DOI BLM NV S010 2018 0051 EIS

GEMINI SOLAR PROJECT

Appendix L: Public Comment, Responses, and Revisions to the Draft Resource Management Plan Amendment/Draft Environmental Impact Statement

December 2019

Figure 2-12 Cross Section of Typical Roads

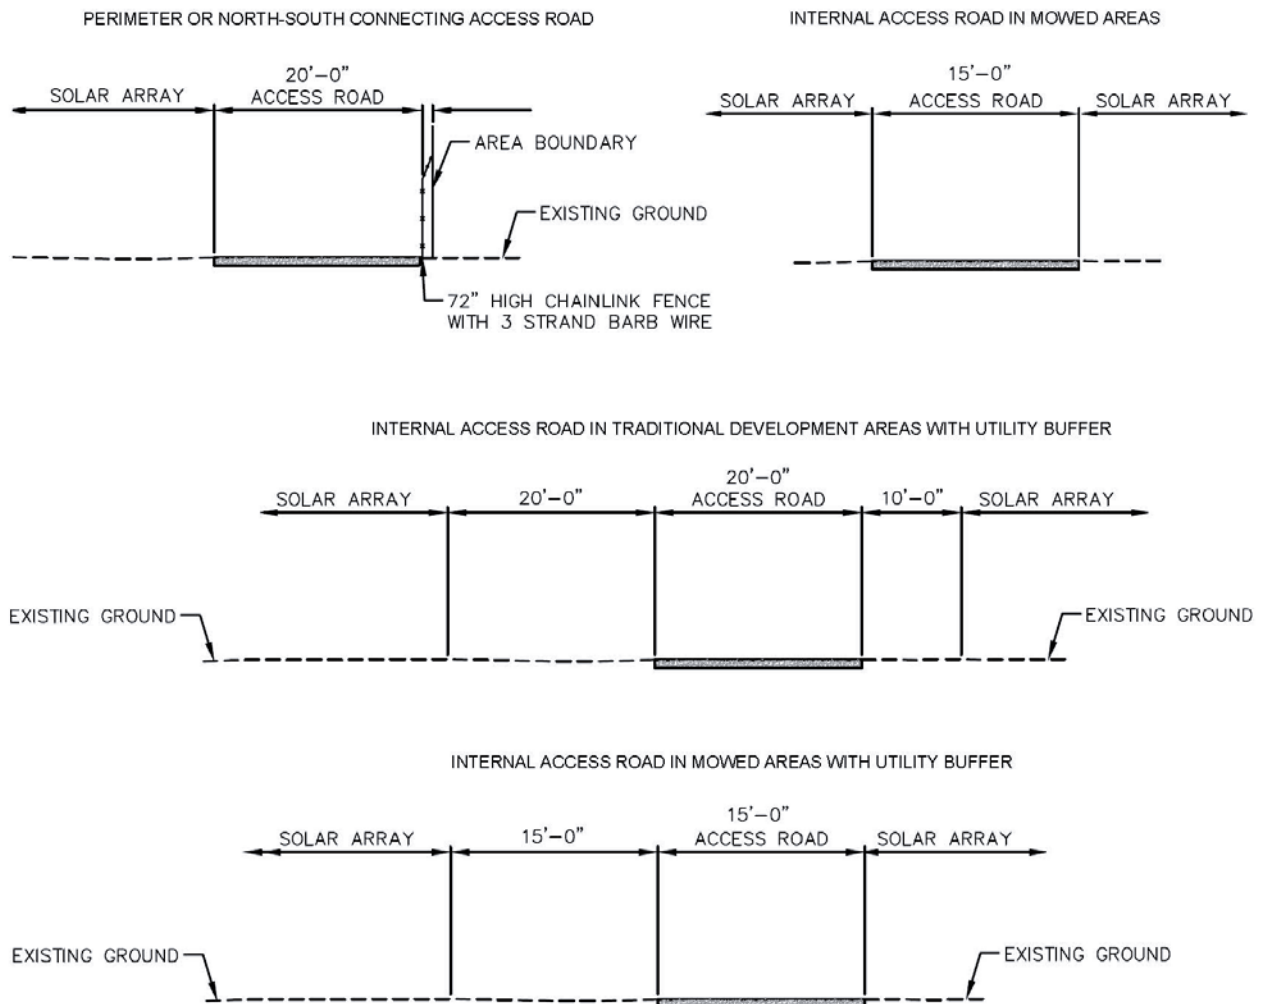
B9-66	9/5/2019	Graf, Ricardo	Solar Partners, LLC	Project Description	Appendix D Figures; Is this a “typical” road (i.e., 50 feet wide and also bordered by the perimeter fence)? Are all the roads for the project like this? Where in (or outside) the project would this kind of road be located? In other words, a better diagram of the different kinds of roads is warranted.	Access road widths and composition of substrate would vary depending on location, as well as between the Proposed Action and action alternatives. Figure 2-12 currently shows what a typical internal access road proposed within traditional development areas would look like. To avoid confusion, Figure 2-12 has been replaced with a figure to more accurately show the range of roadway types proposed. Refer to Chapter 2: Proposed Action and Alternatives for descriptions of the various roadways proposed.
B9-67	9/5/2019	Graf, Ricardo	Solar Partners, LLC	Geology, Soils, and Mineral Resources	Appendix H Mitigation, Monitoring, Reporting Measures; First bullet point: Remove the term “offsite washes.” Clark County will have jurisdiction oversight of the Drainage Study and they require the downstream impacts be mitigated prior to leaving the site. If improvements to washes are required, they must be “onsite.”	It is acknowledged that the Clark County RFCD would review and have jurisdiction to approve the Drainage Study (Table 1.6-1 of the Draft RMPA/EIS). In accordance with the Hydrologic Criteria and Drainage Design Manual, the flow and rate of flow downstream shall not increase from upstream uses, within reason, unless existing drainage systems are capable of handling the increase (Sections 303.1.1 and 303.1.2). The policy of Clark County is to require new developments to construct private on-site flood control facilities. Erosion associated with changes or increases in flow must be managed on-site. The intent was for any washes within the Project area but not within the fence lines. MM GS-1 has been revised to clarify the installation of erosion control and bank stabilization devices on Project area washes.

Figure 2-12 is replaced as follows:

Figure 3.0-2 Local Cumulative Projects in the Project Area

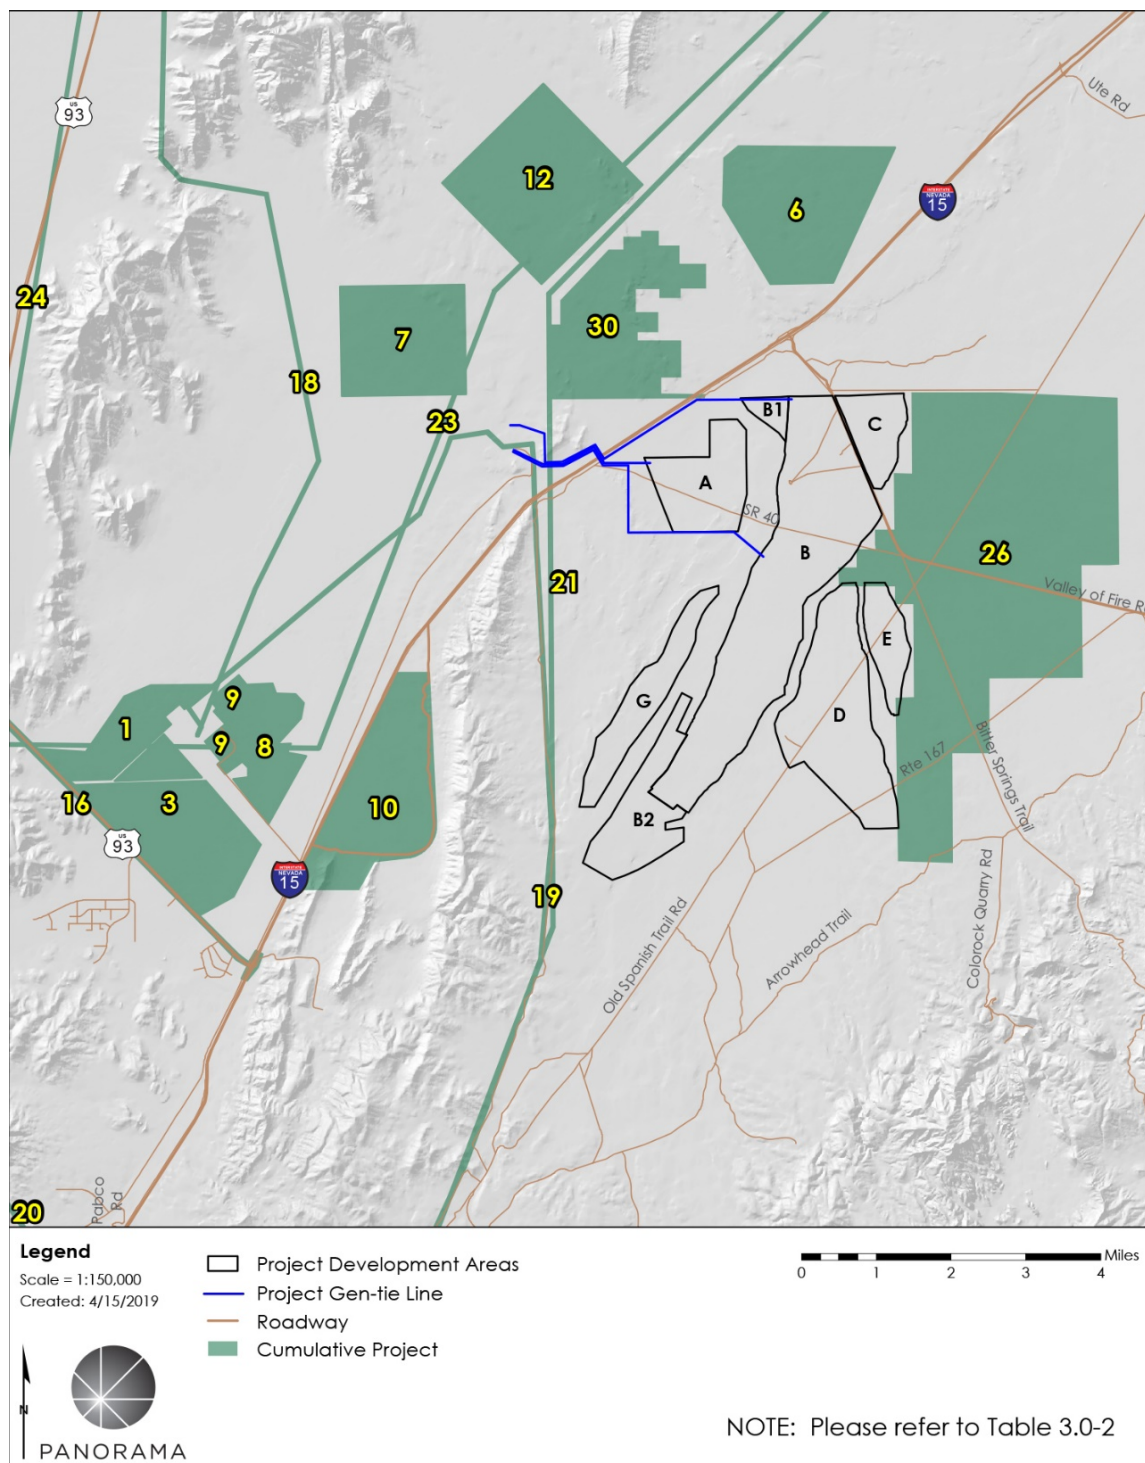
A1-7	9/5/2019	Dunning, Connell	USEPA	Air Quality and Climate Change	Recommendations: Revise Table 3.0-2 and Figure 3.0-2 to include Arrow Canyon Solar and Southern Bighorn Solar and Storage Center and provide an estimate of emissions from these, and any other neighboring projects that will be constructed during 2020-2023, to better understand the Gemini Solar Project contributions to cumulative air impacts.	Refer to Response to Comment A1-6 for information regarding the cumulative air quality analysis.
A1-8	9/5/2019	Dunning, Connell	USEPA	Air Quality and Climate Change	Coordinate with the Clark County Department of Air Quality to develop a phased construction schedule for Gemini, and other projects expected to undergo construction concurrently, to comply with local, state and federal air quality regulations.	Project construction is proposed to be phased over several years, as was noted on page 2-5 of the Draft RMPA/EIS. This phasing was incorporated into the air pollutant modeling (refer to supplemental information in the Air Quality and Climate Change Technical Report for more information). Refer to Response to Comment A1-2 for information about ongoing coordination with Clark County.

Revise Table 3.0-2 and Figure 3.0-2 to include Arrow Canyon Solar and Southern Bighorn Solar and Storage Center and provide an estimate of emissions from these, and any other neighboring projects that will be constructed during 2020-2023, to better understand the Gemini Solar Project contributions to cumulative air impacts.

Figure 3.0-2 is replaced as follows:

Figure 3.6-21 Areas of Drive and Crush in Traditional Development Areas as Required Under MM VG-2

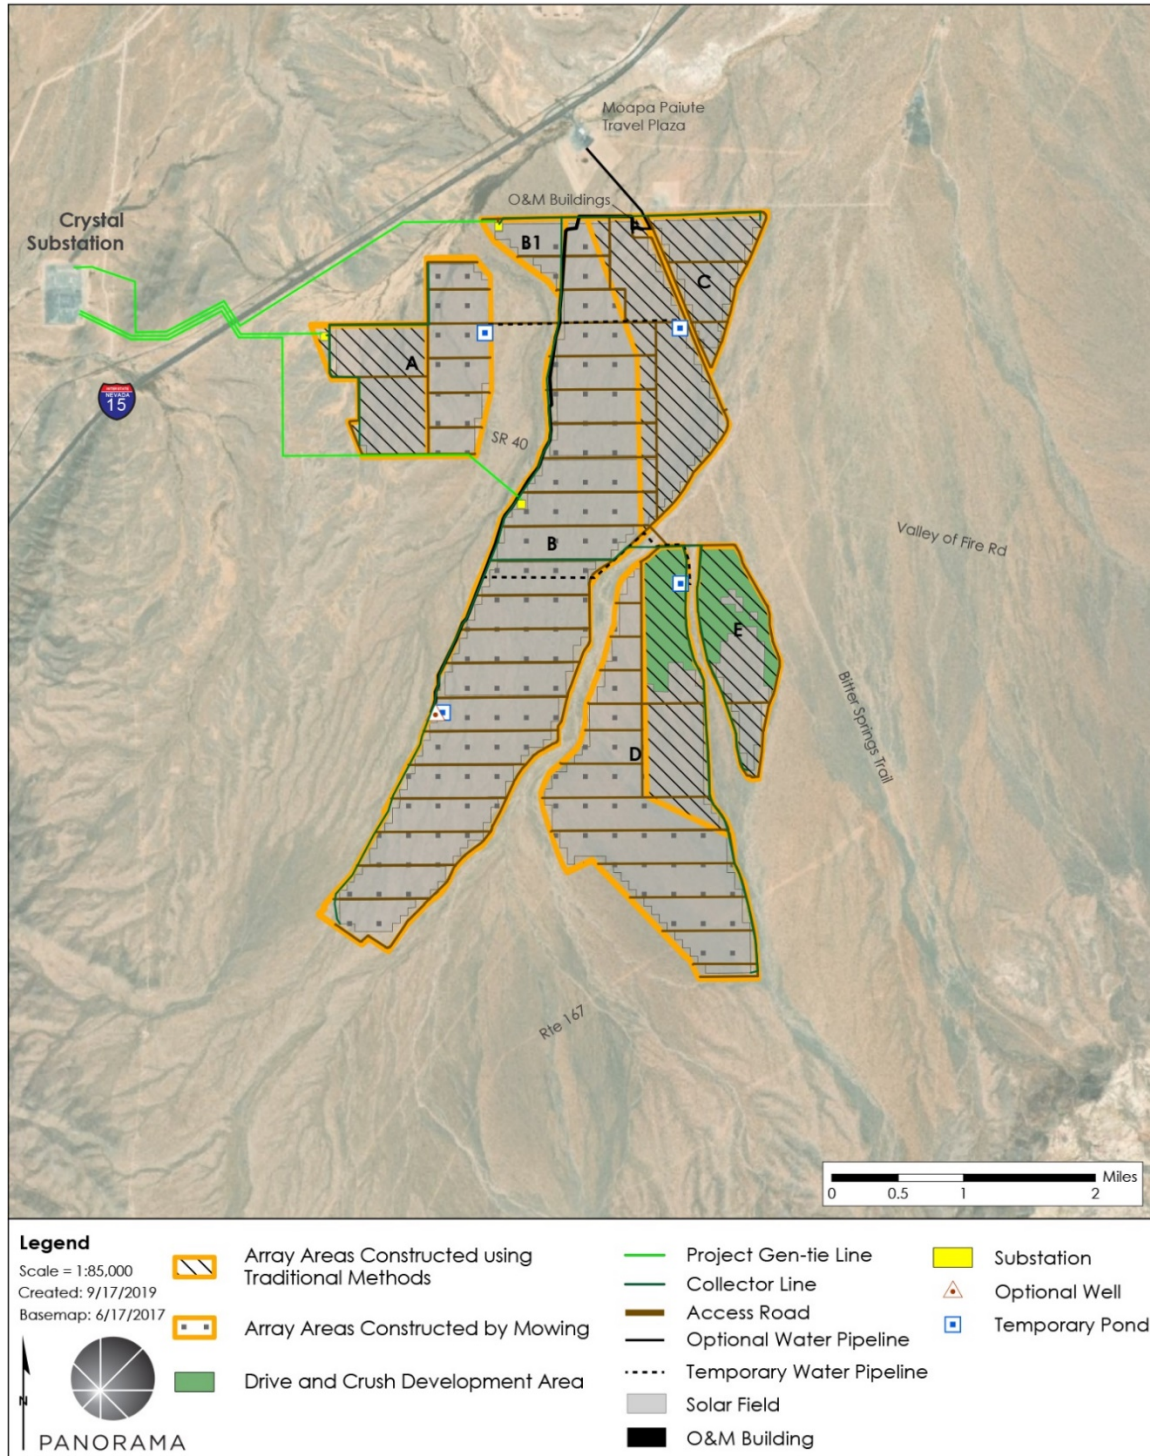
A1-30	9/5/2019	Dunning, Connell	USEPA	Vegetation and Jurisdictional Waters	Include additional figures that illustrate where disk and roll versus drive and crush will be used in traditional development areas in the FEIS.	An additional figure (Figure 3.6-21) has been added to Appendix D in the Final RMPA/EIS to show the drive and crush areas.
A1-31	9/5/2019	Dunning, Connell	USEPA	NEPA and Decision Process	Include the Site Restoration Plan and Site Decommissioning Plan in the FEIS or post the documents on the BLM's ePlanning website.	The Site Restoration Plan and the Decommissioning and Site Reclamation Plan have been included for posting on ePlanning website with the Final RMPA/EIS.
A1-32	9/5/2019	Dunning, Connell	USEPA	Vegetation and Jurisdictional Waters	Clarify whether MM VG-2 applies to all traditional development areas in the Project site - including areas A and B - or just traditional development areas in C, D, and E.	The areas of applicability for MM VG-2 are stated as in "modeled habitat for threecorner milkvetch" in Appendix H. This reference has been edited in the Final RMPA/EIS Appendix H to indicate that the measure applies to "All Project areas." Where specific aspects of the measure only apply to threecorner milkvetch habitat, only development areas D and E would be included. There is no modeled threecorner milkvetch habitat in development areas A, B, or C, as shown in Figure 3.6-18 of Appendix D and referenced in MM VG-2 for the Hybrid Alternative and All Mowing

Figure 3.6-21 is added as follows:
